3-22-01  
THURS

SKW 1410 @ WLFD

Pond D -

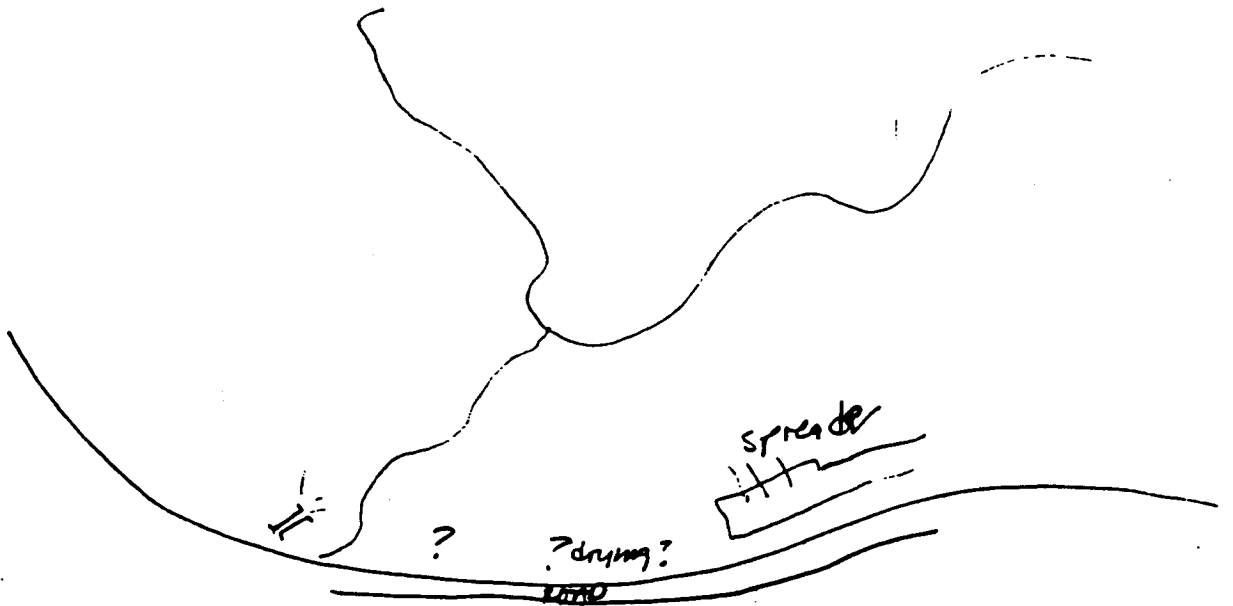
If seasonal ground water max at 336 ft then WL isn't fed by  
GW but SW or shallow interflow + pond will intercept it + direct it away  
from WL. → Pond D will intercept hydrology to WL.  
Infiltration facility for 0.2 cfs capacity. No drawings for  
facility (Kelly has asked for drawings)

stormwater  
If features fail, they will affect natural features.
